Addendum No. 1

Re: Part B - James M. Seals, JR. Park – Athletic Restroom/ Concession and Field Improvements
504 Texas Street, Mobile, AL 36603
Project No. PR-041-20
Part C - Hackmeyer Park – Improvements Phase 2
3810 Conway Drive South, Mobile, AL 36608
Project No. PR-034-21

Date: November 14, 2022

D GABION PEDESTRIAN BRIDGE GUARDWALL

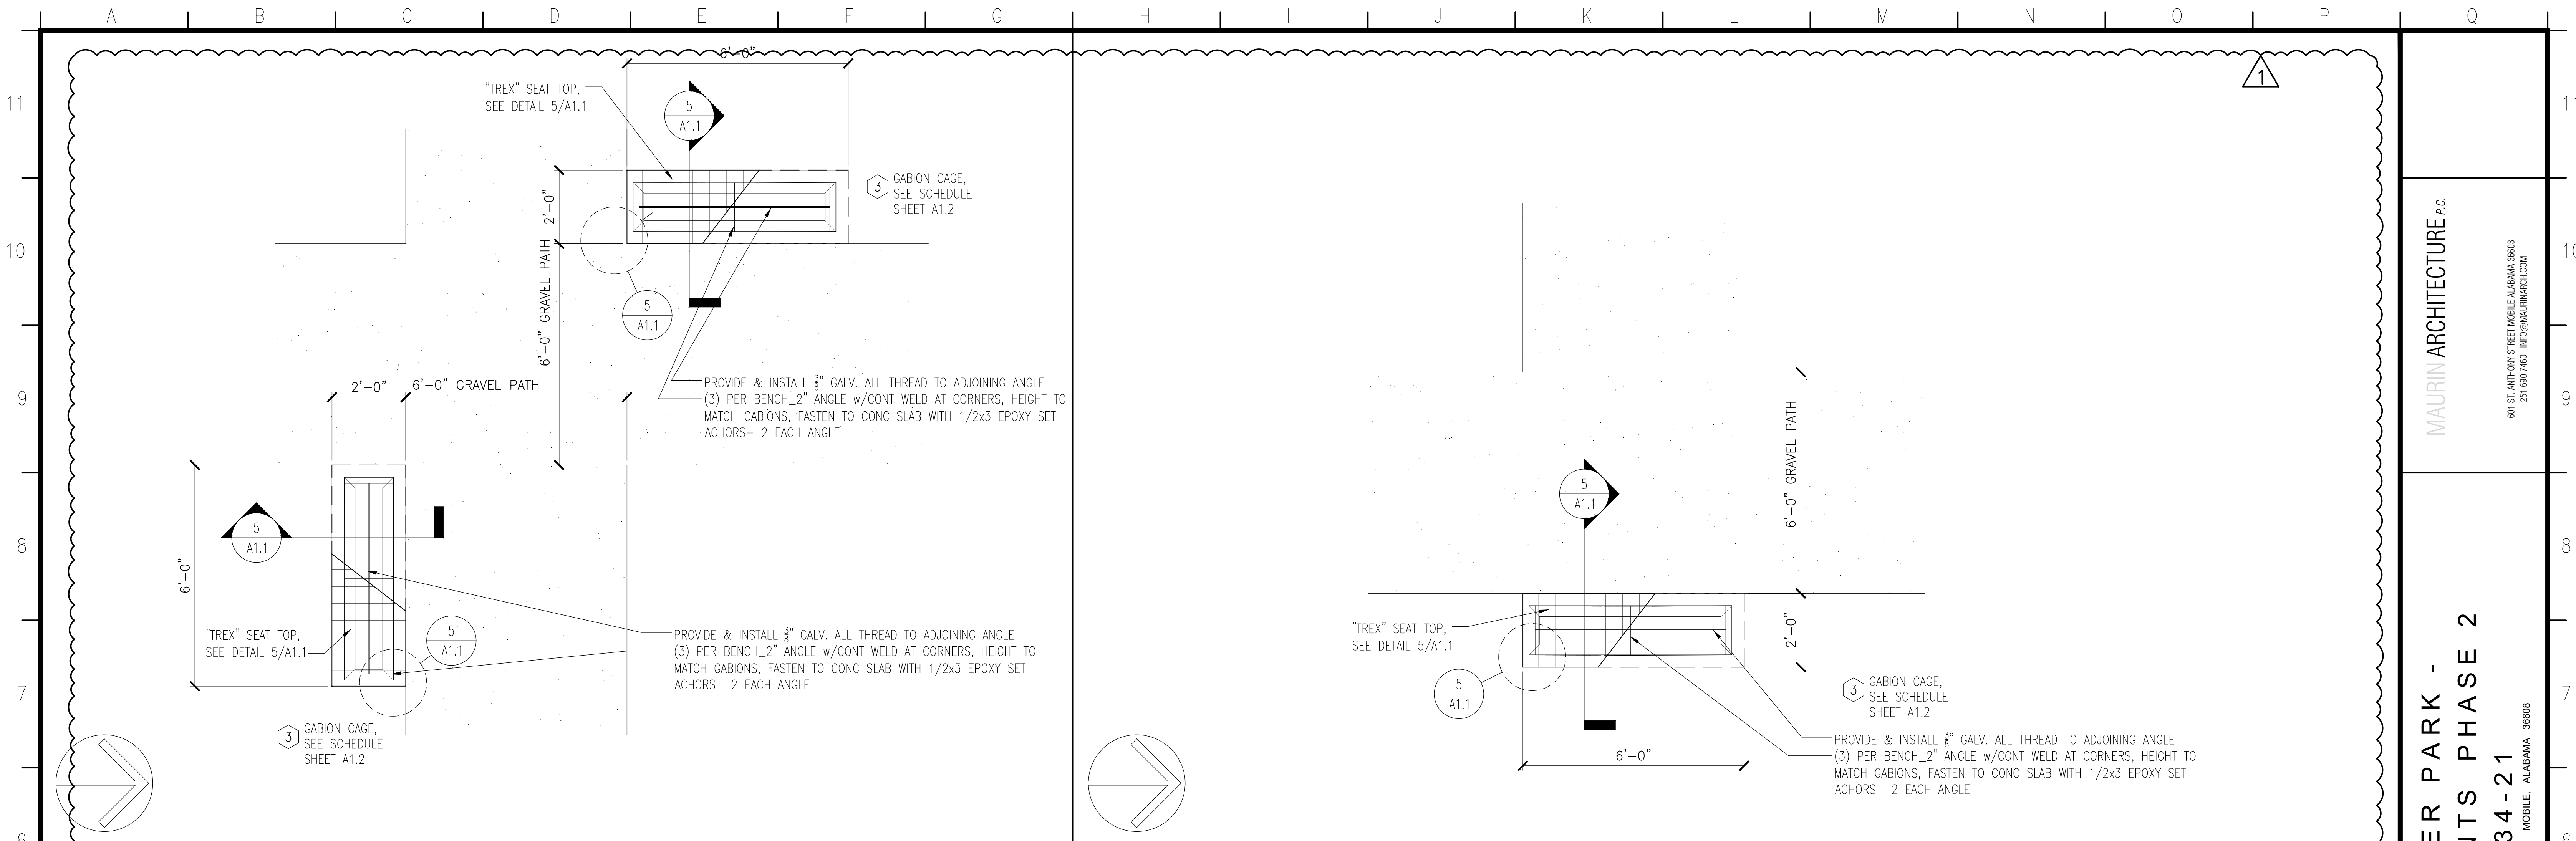
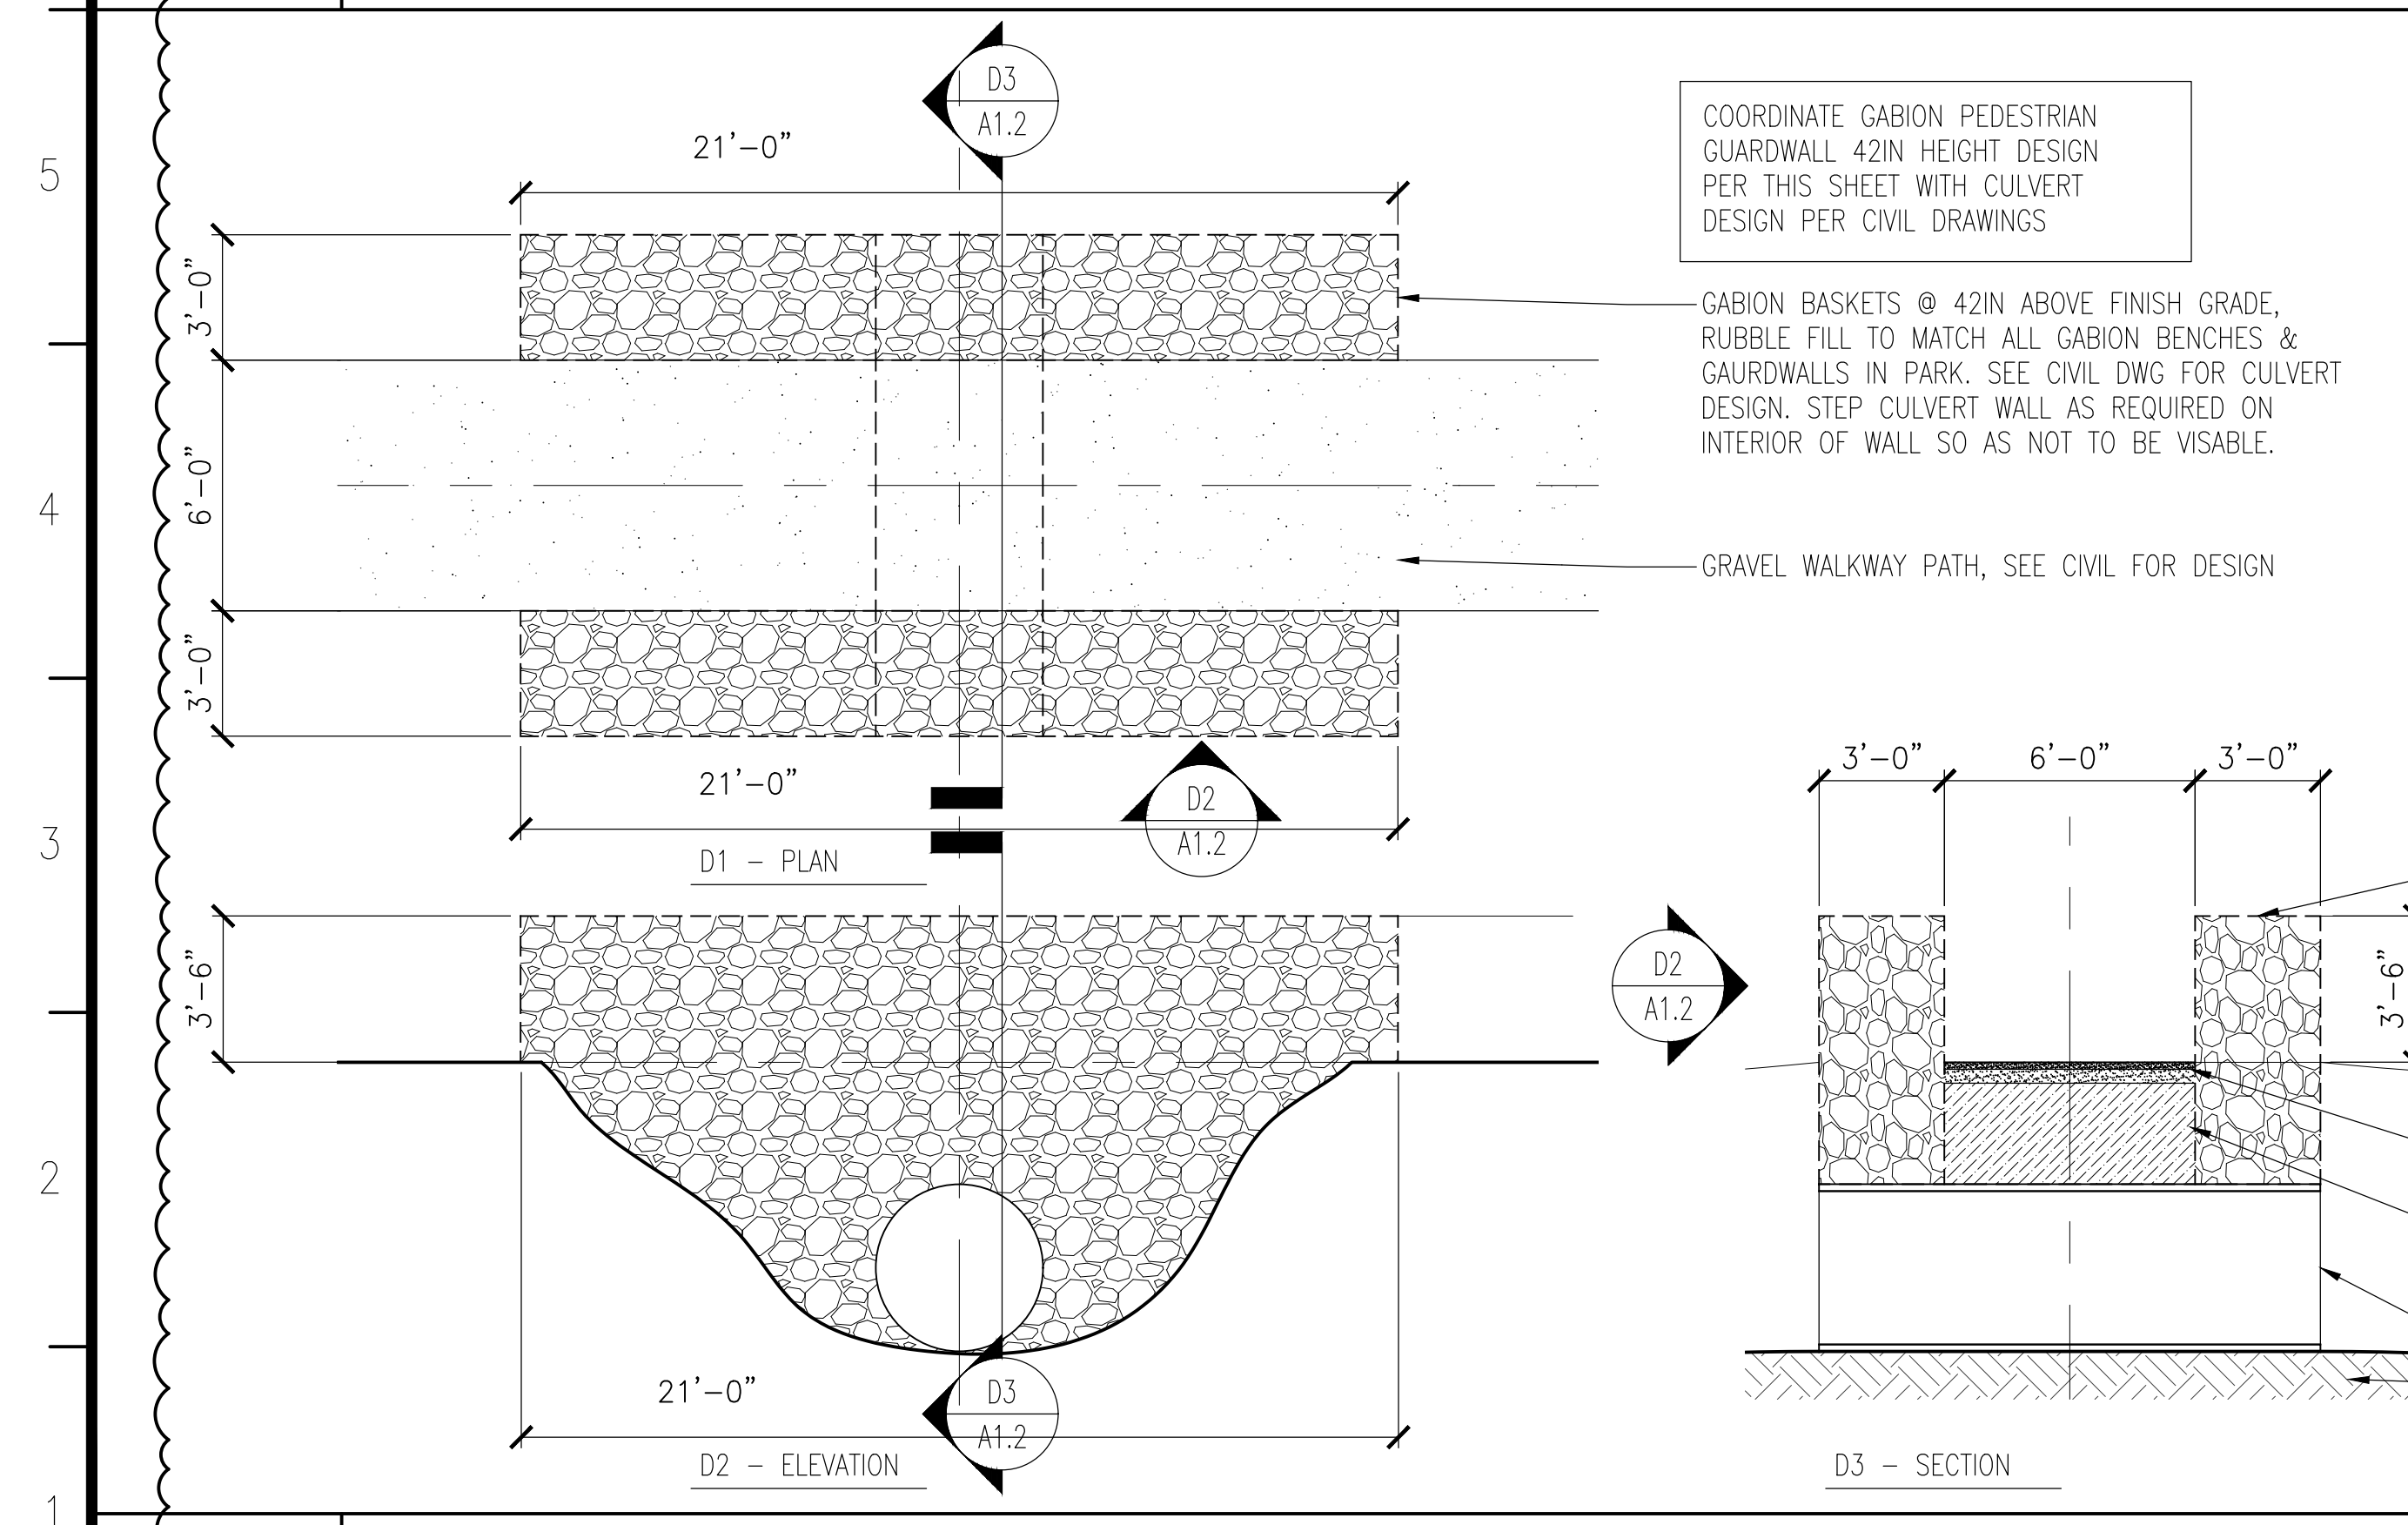
- Item 3: Sheet A1.2 Details – Gabion Bridge & Benches
Replace this sheet dated 11.02.22 with the attached revised sheet of same title A1.2, dated November 07, 2022 and labeled Revision 01 (Addendum No. 1). Substantial changes include the following:
Update Gabion Bench Schedule.
Update Gabion Bench details.
Update Gabion Bridge Guard wall details.
